Technical Note – Applicant Response to LLFA Comments

- 1.1 This Technical Note (TN) has been created by Mayer Brown Ltd (MBL) to address the consultation comments received from Wiltshire County Council, acting as the Lead Local Flood Authority (LLFA), in response on the Flood Risk Assessment (FRA) and Drainage Strategy that accompanied the planning application for the proposed new Lidl store at Land East of Eastern Way and South of Sandridge Common, under Planning Reference **PL/2026/02458**.

Lidl Great Britain Ltd, Eastern Way, Melksham

Applicant Response to LLFA Comments

Figure 1.2: Nearest Watercourse – Clackers Brook 400 metres south

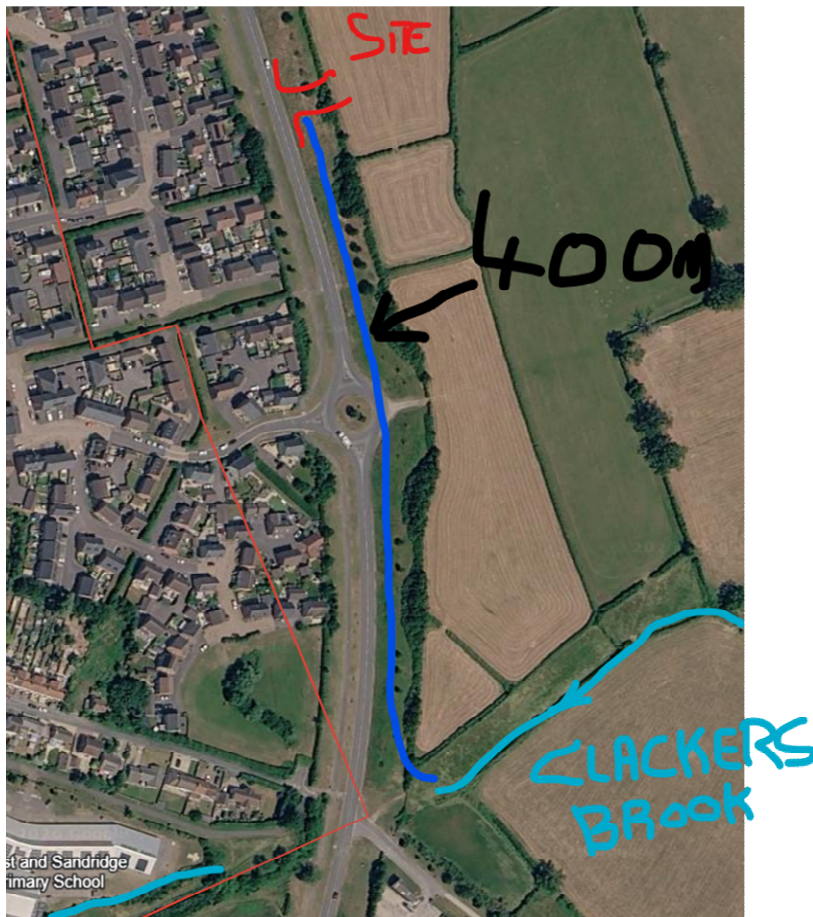
- There are no watercourses available for discharge within a reasonable proximity to the site. The nearest watercourse is Clackers Brook located approximately 400 metres south of the Development access as can be seen in Figure 1.1 below. The only way to reach this watercourse is via the highway verge, but this is dedicated to WCC only and the subsoil is actually owned by a consortium of residential Developers. Lidl have approached one of the Developers who have confirmed there will be a considerable cost imposed upon running a 400 metre outfall pipe through the highway verge.

- 1.17 Upon review of the discharge options available, we believe a restricted discharge into the highway sewer on Eastern Way is the most appropriate option within the drainage hierarchy. The proposed discharge location is shown on the updated drainage general arrangement plan in Appendix E.
- 1.18 For these reasons, we consider the submitted information demonstrates compliance with Standard 1 by following the drainage hierarchy and selecting the most appropriate discharge destination.
